Product Change Notification / CENO-02KHGL616

CCB 5240 Final Notice: Qualification of MTAI as a new final test site for selected SST39LF0xx and SST39VF0xx device families available in 32L PLCC (11.5x14x3.37mm) package.

PCN #: CENO-02KHGL616

Tape and Reel – Carrier Tape

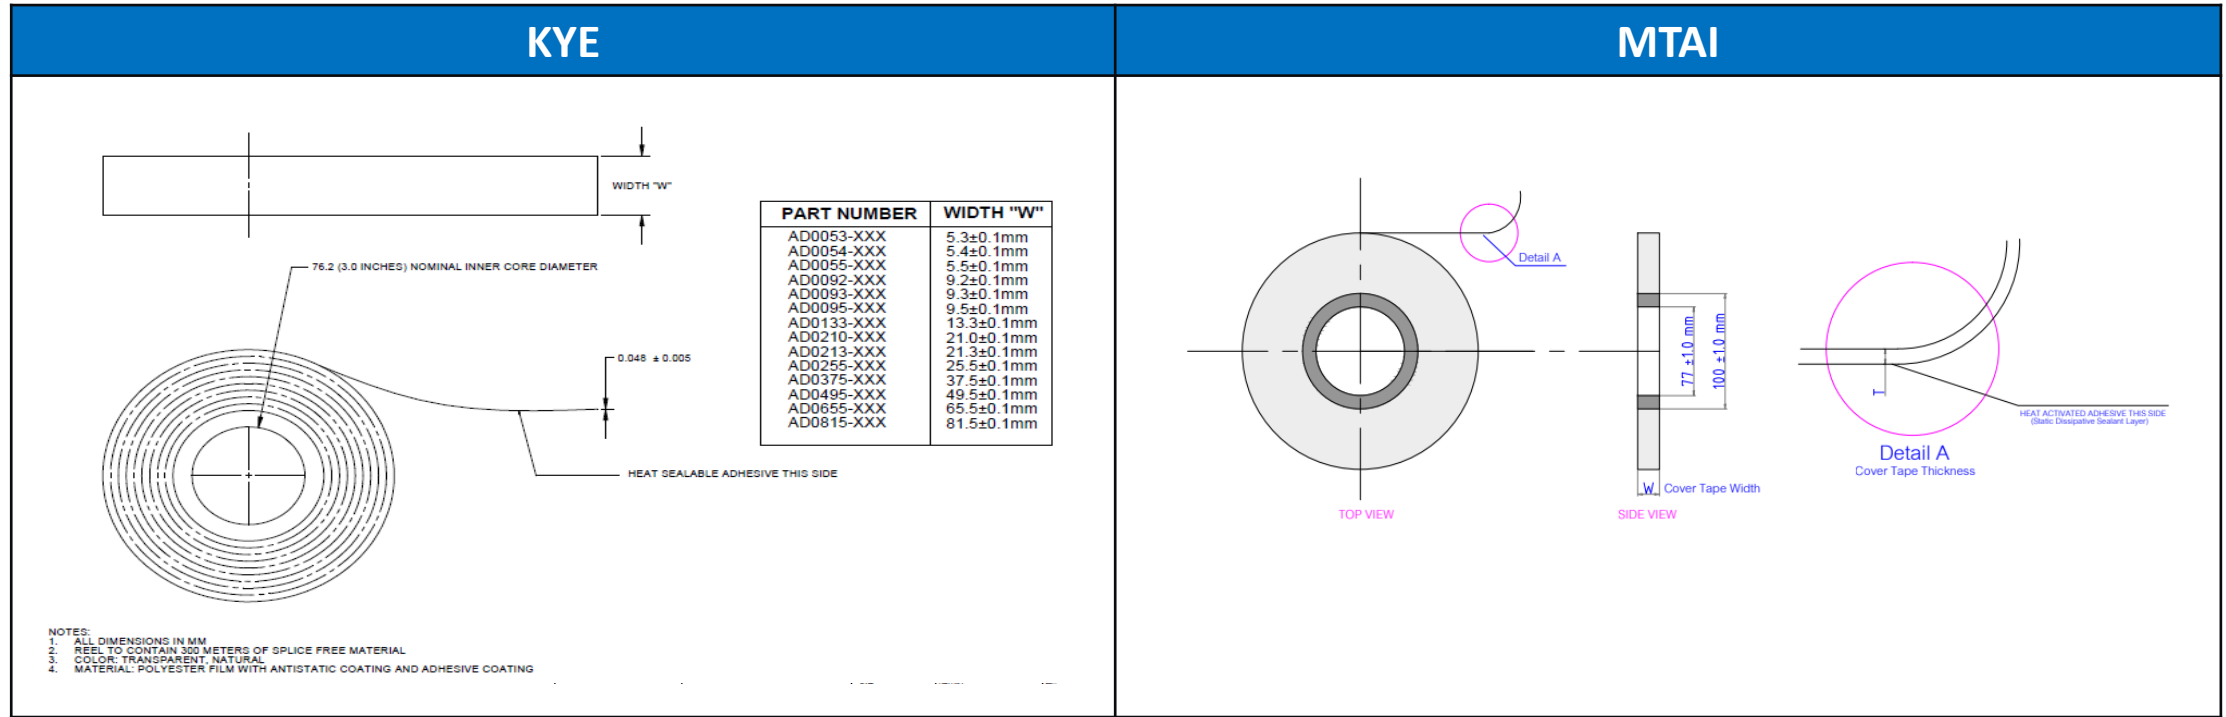
| Plant | W (mm.) | P (mm.) | A0 (mm.) | B0 (mm.) | K0 (mm.) | K1 (mm.) | Thickness | BQM | Pin1 |
| KYE | 24.00 ±0.30 | 16.00 ±0.10 | 13.10 ±0.10 | 15.50 ±0.10 | 3.90 ±0.10 | - | 0.30 ±0.05 | 750 | Quadrant 1-2 |
| MTAI | 24.00 ±0.30 | 16.00 ±0.10 | 13.10 ±0.10 | 15.50 ±0.10 | 3.90 ±0.10 | - | 0.30 ±0.50 | 750 | Quadrant 1-2 |
